DA2022/0107 - Bentley Quarry – Response to TIA Peer Review

Table 1 Peer Review

Traffic Impact Assessment

Bentley Quarry

R & S CONTRACTING Pty Ltd
BENTLEY QUARRY
Lot 2 DP 1196757, No. 1465 Bentley Road
BENTLEY ROAD SITE ACCESS
TURN PATHS - SHEET 1 OF 2

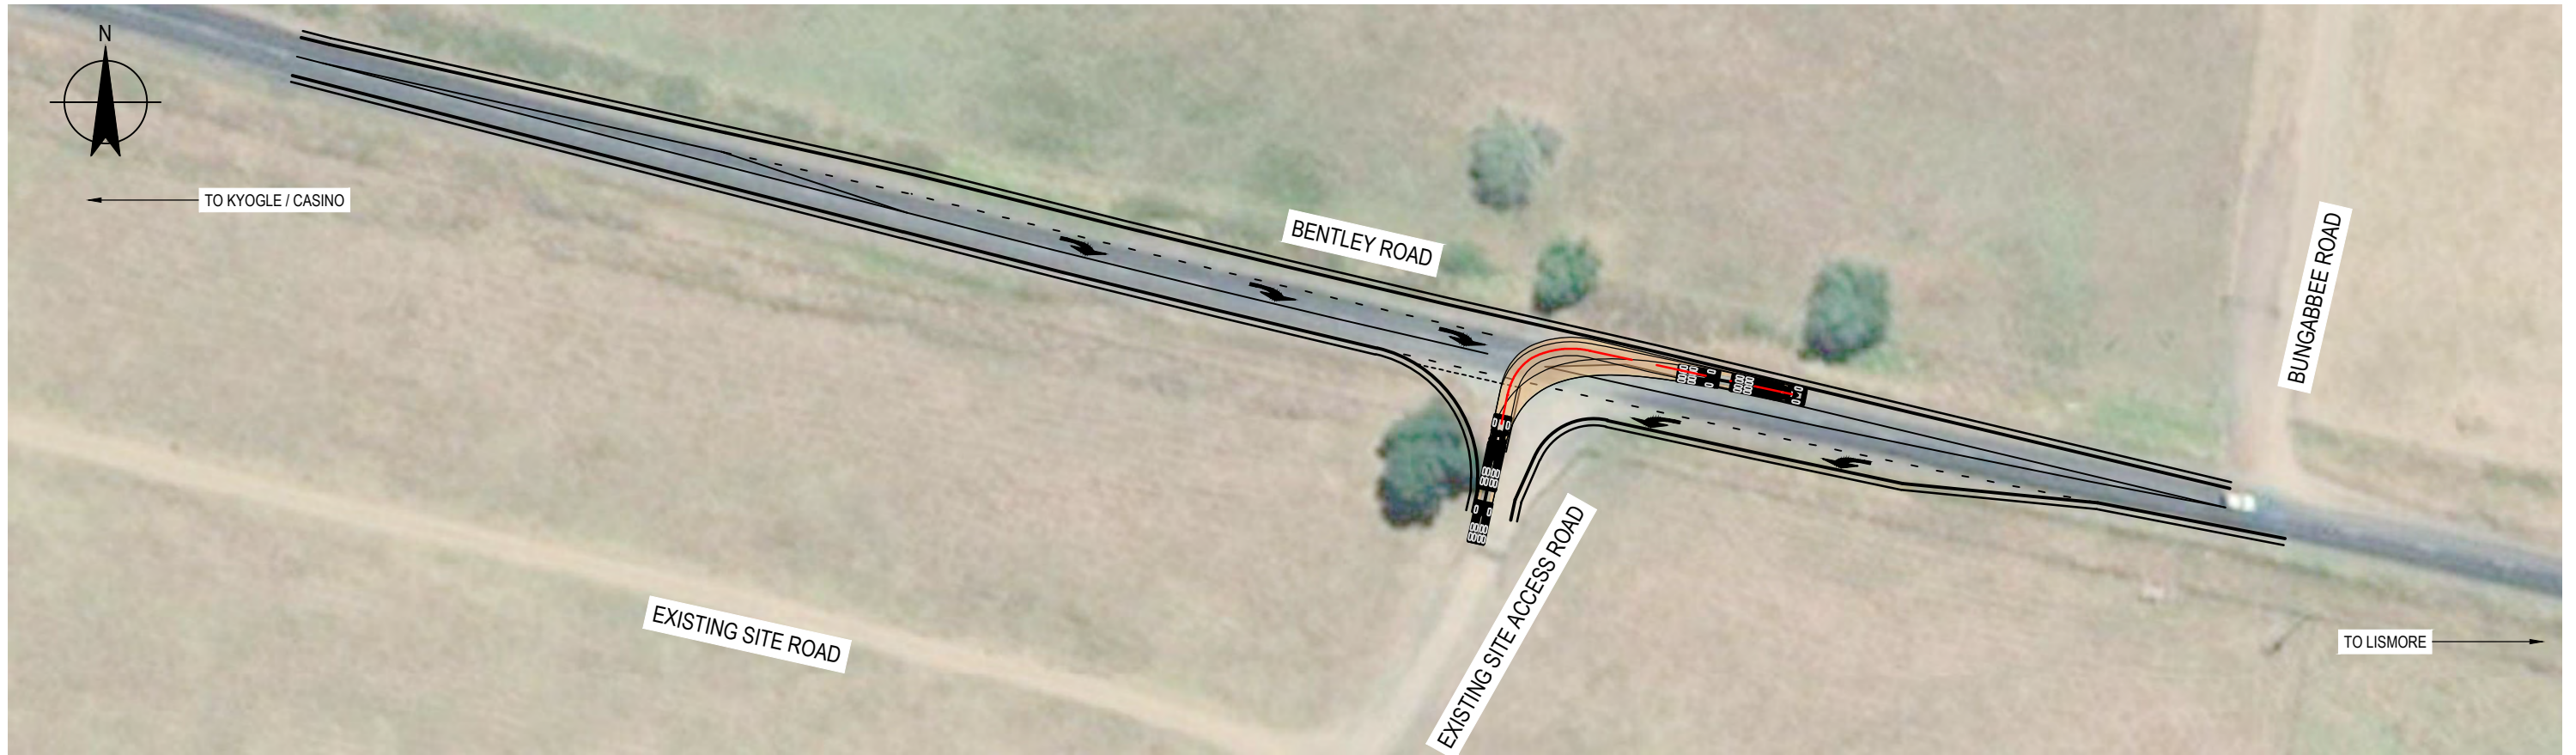
| Item | GHD TIA Reference | Summary | Inadequacies and shortcomings | EMM recommendations | Category | Response |
|------|-------------------|----------------------------------|--|---|----------|--|
| 12 | Appendix A | Site access intersection upgrade | The report states that truck and dog trailer combinations will be used to transport quarry material by the development. The proposed intersection upgrade concept plan does not show a swept path assessment of a truck and dog trailer entering and exiting the upgraded site access intersection. | The intersection upgrade concept should show a swept path assessment by the longest vehicle entering and exiting the site, total four movements to/from the east and the west (in & out). Further comments on the intersection concept plan proposed are provided in the following chapter. | High | Swept path assessment has been provided in the revised report. The design has been updated to accommodate the swept paths and this will be further refined during detailed design stage. |

| Item | GHD TIA Reference | Summary | Inadequacies and shortcomings | EMM recommendations | Category | Response |
|------|-------------------|----------------|-------------------------------|---|----------|---|
| 15 | Appendix A | Concept design | | As stated earlier, no swept paths are shown or considered. The design will have significant variance once swept paths are applied, as to account for the use by specific trucks. This will affect the kerb returns, positioning of the holding line, configuration of the intersection and shape of the median. Consequently, this concept design does not effectively show the true extent of works. | | The concept design has been updated as suggested. |
